NEI White Papers on Crediting Portable Equipment in RI Decision Making (Comments from NRC)

NEI FRIDM Task Force
March 16, 2016
NRC Public Meeting at One White Flint

Streamlined Approach for Crediting Portable Equipment in RI Decision Making (Comments from NRC)

NEI FRIDM Task Force
March 16, 2016
NRC Public Meeting at One White Flint

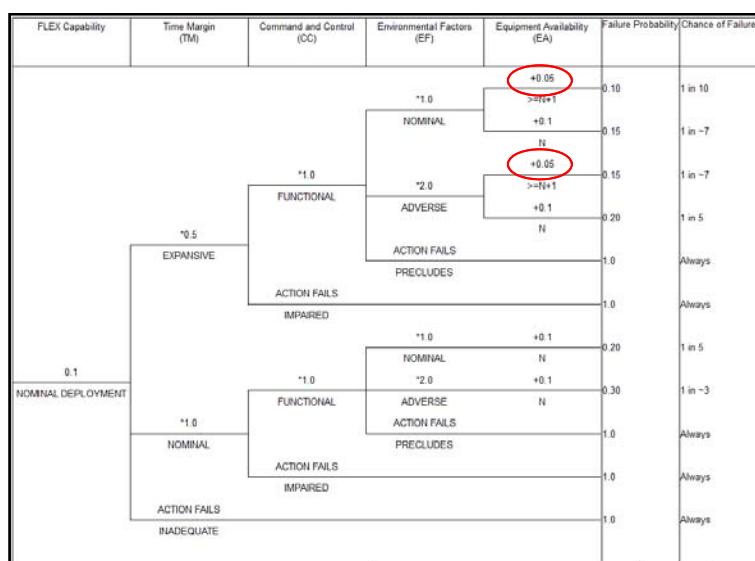
Issue #2: Missing Diagnosis Element in Quantitative Analysis

- Uses a holistic construct to assign an overall failure probability for implementing a mitigation strategy
- It does not represent a specific human reliability analysis methodology
- However, white paper will be updated to note that the assumed delay time will encompass the diagnosis time
 - Cognitive portion of HEP embedded in overall failure probability

Example Case (Cont'd)

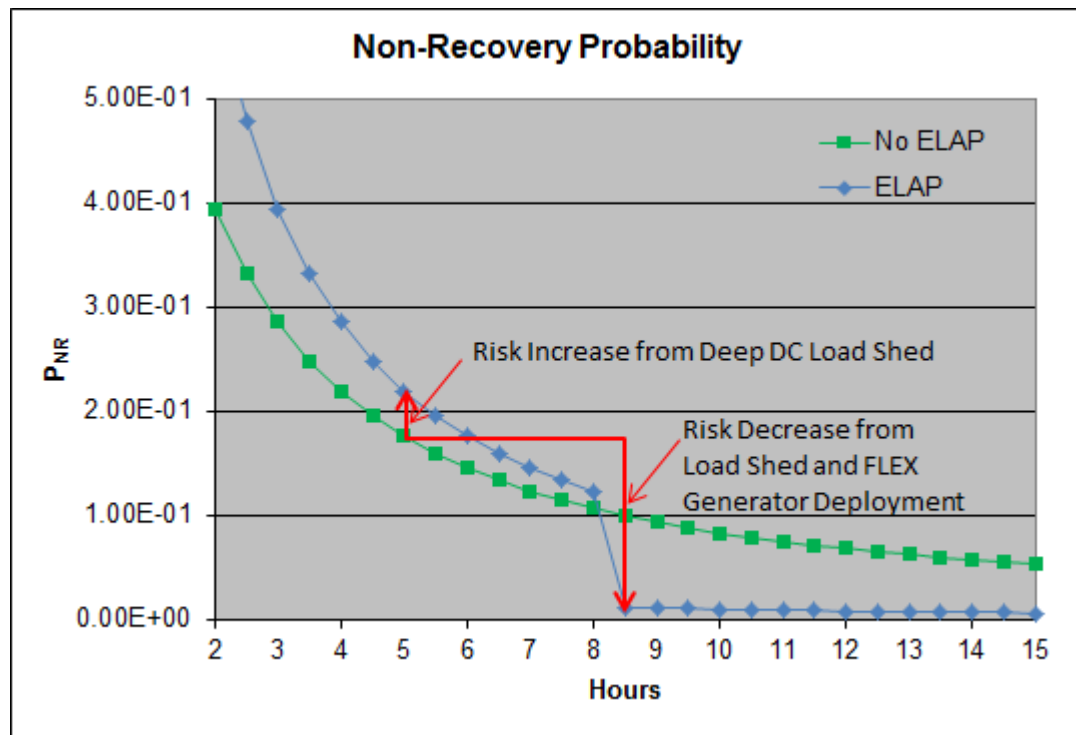
Issue #4: Potential Negative Impacts Associated with Deep DC Load Shedding

- In the streamlined approach, the unaccounted for risk decrease should always be larger than the unaccounted for risk increase
 - Assumes extra time available from extended battery life is more than any extra time required to restore power if it becomes available
 - Exception would be if deep load shed precludes timely off-site or on-site power restoration
